Trudeau Building Rehabilitation

Addendum #2: Historic Saranac Lake – Trudeau Building Rehabilitation
PROJECT LOCATION: Reconstruction at 118 Main Street, Saranac Lake, NY 12983
Issue Date: February 5th, 2023

Please be advised of the changes noted below to the Bidding documents and responses/answers to requests for information and questions received to date during the bidding period.

1 FIRST FLOOR PLAN
A1.1 SCALE: 1/4" = 1'-0"

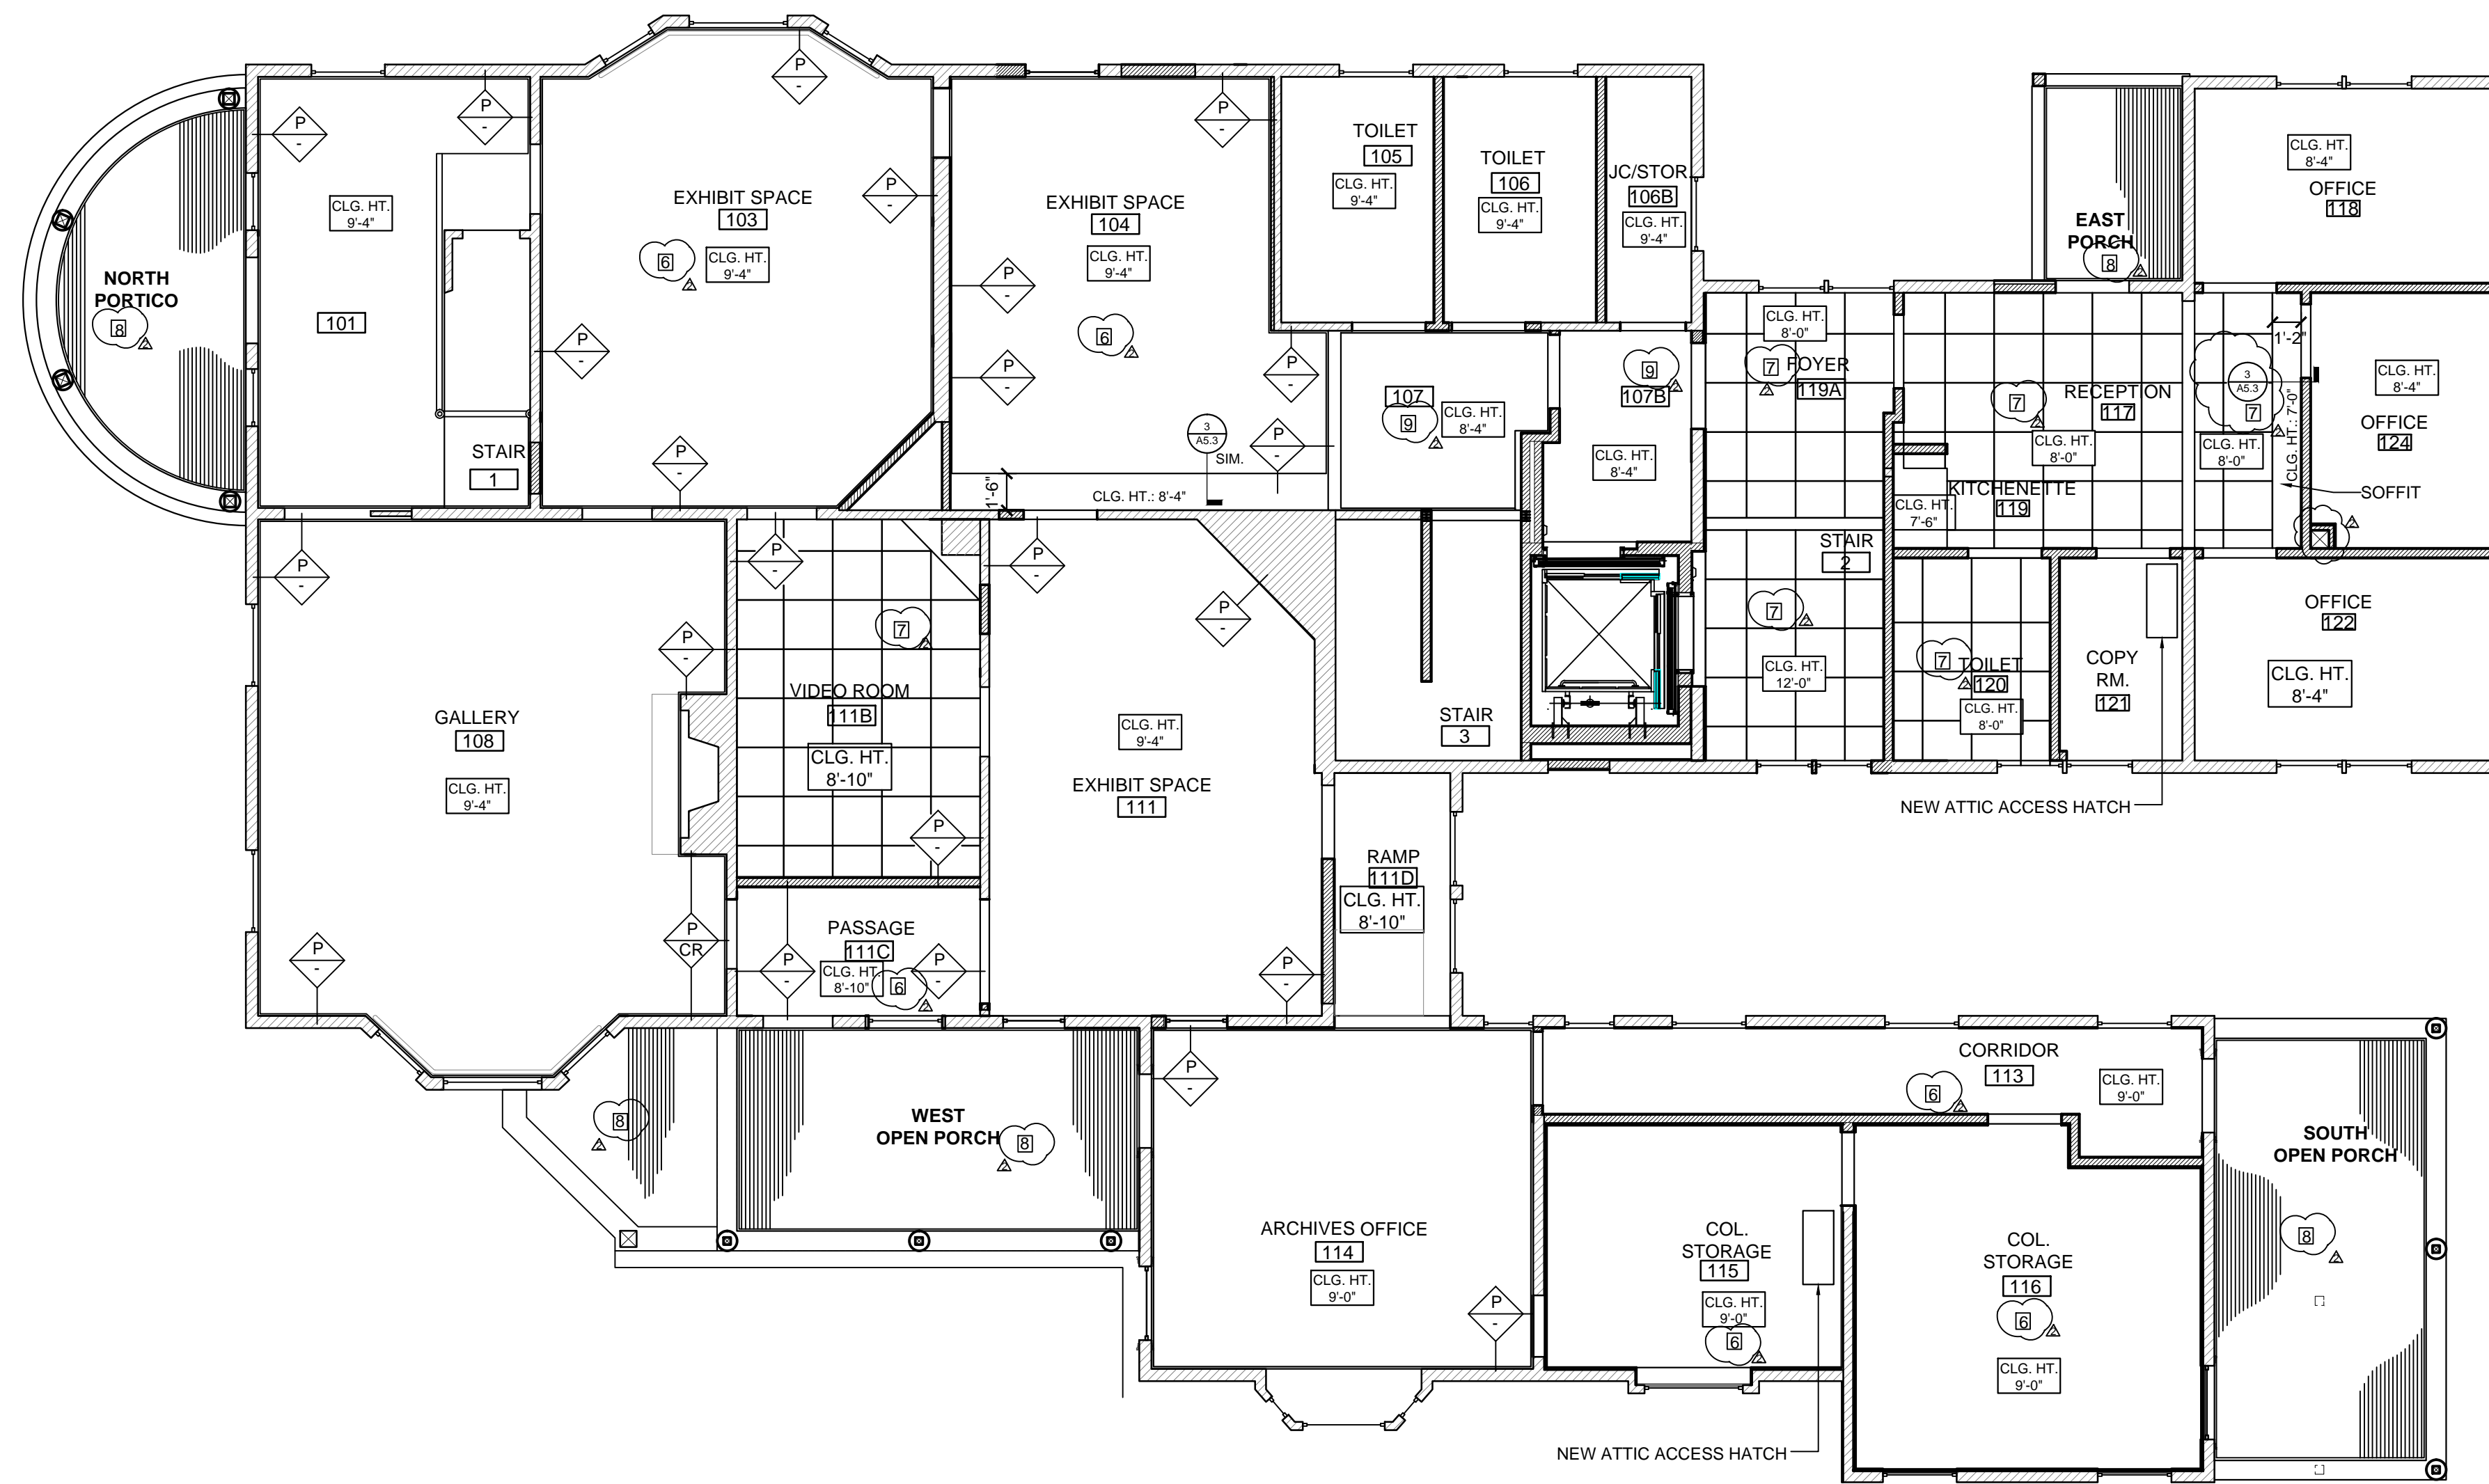
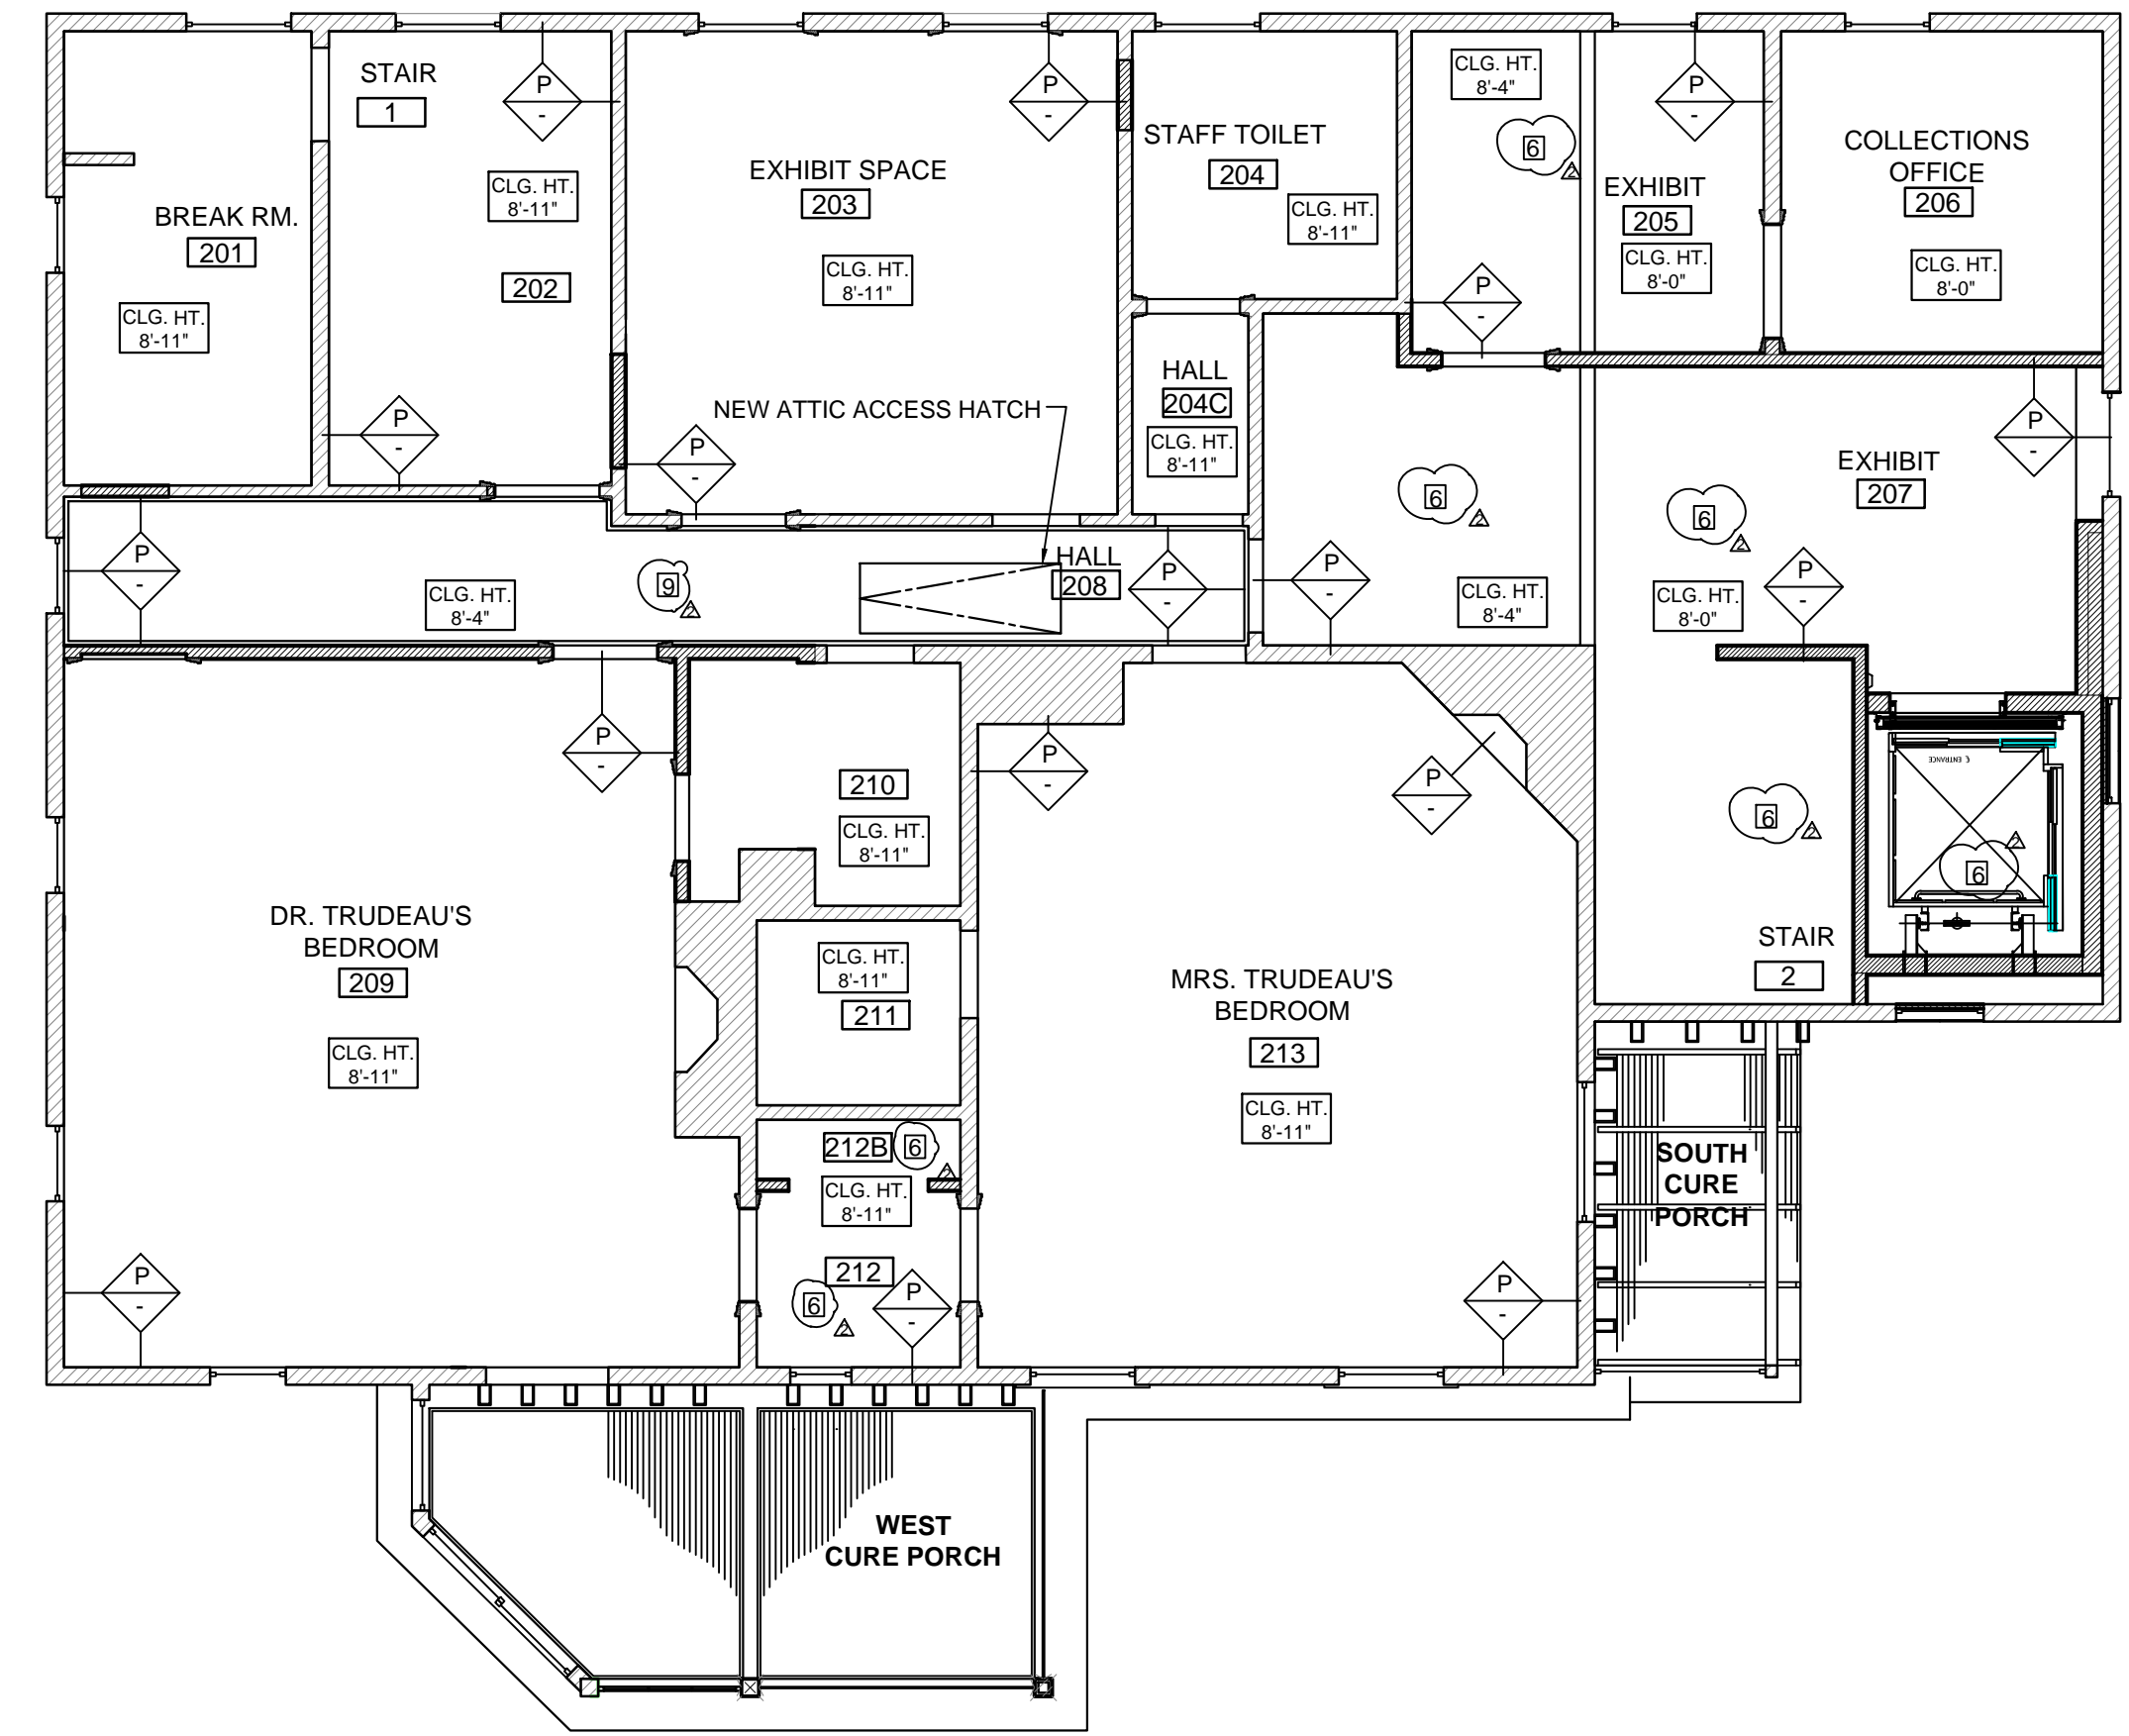
1. 1/A1.1: First Floor Plan
 - a. **Office 124** will have a 12”x12” vertical chase in the NW corner of the room to accommodate an 8”x8” vertical duct connected to an energy recovery unit located in the crawl space below 124 and to a lateral duct within a new horizontal chase on the south side of Reception 117. Walls of the vertical chase are now shown in **Wall Type 2D**.

3 CEILING TYPES/DETAILS
A1.11 SCALE: VARIES

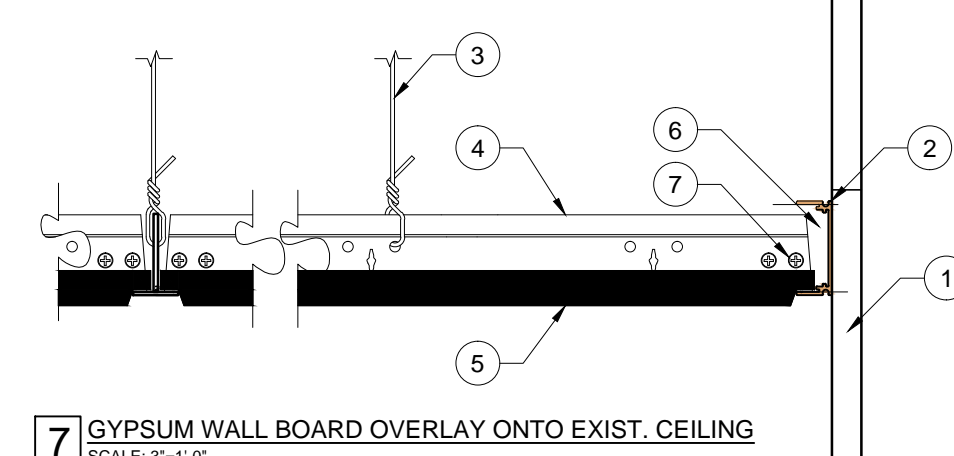
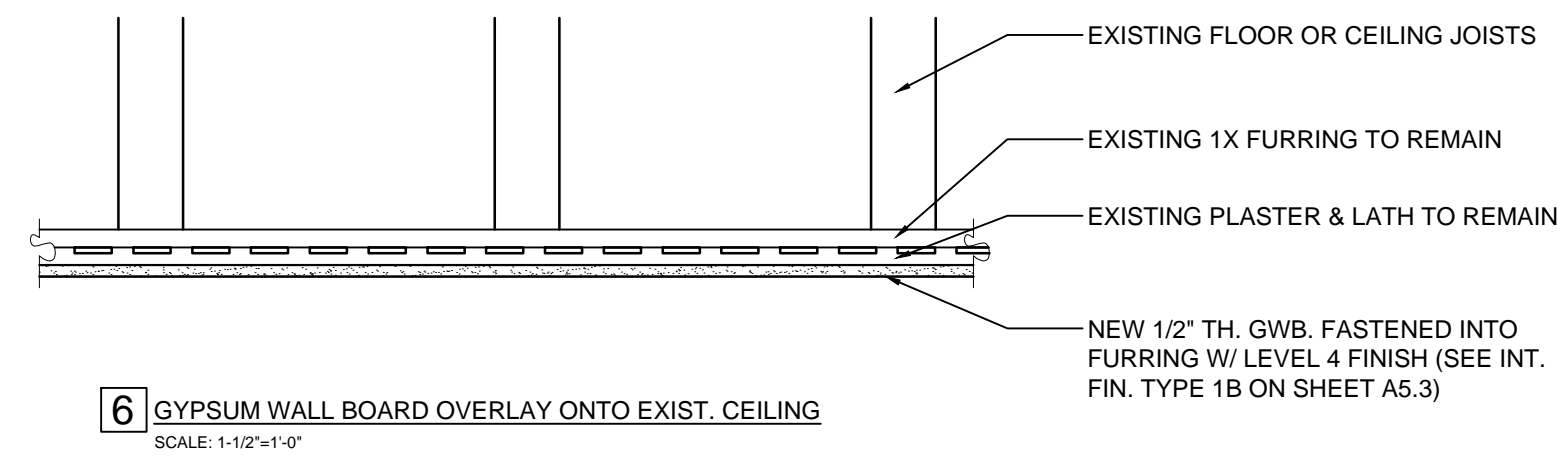
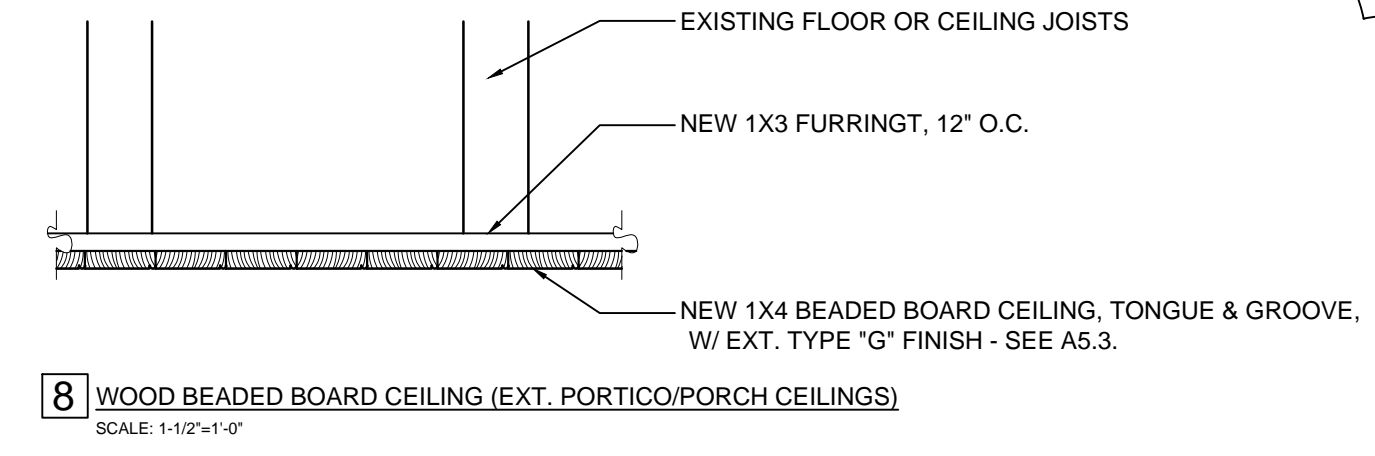
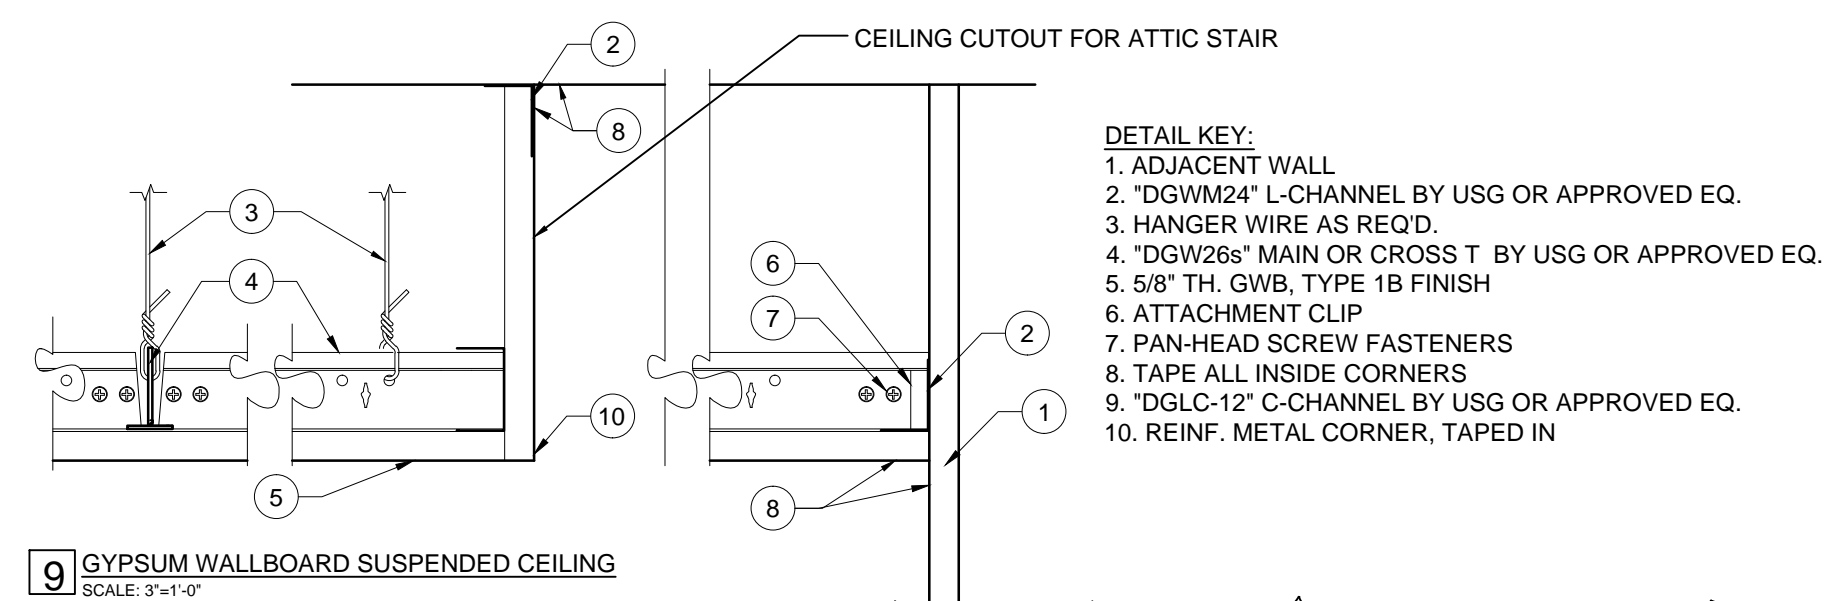
2. 3/A1.11: Ceiling Types/Details (new)
 - a. Ceiling Types **6, 7, 8 & 9** are shown and referenced in the reflected ceiling plans on **1 & 2/A1.11**.
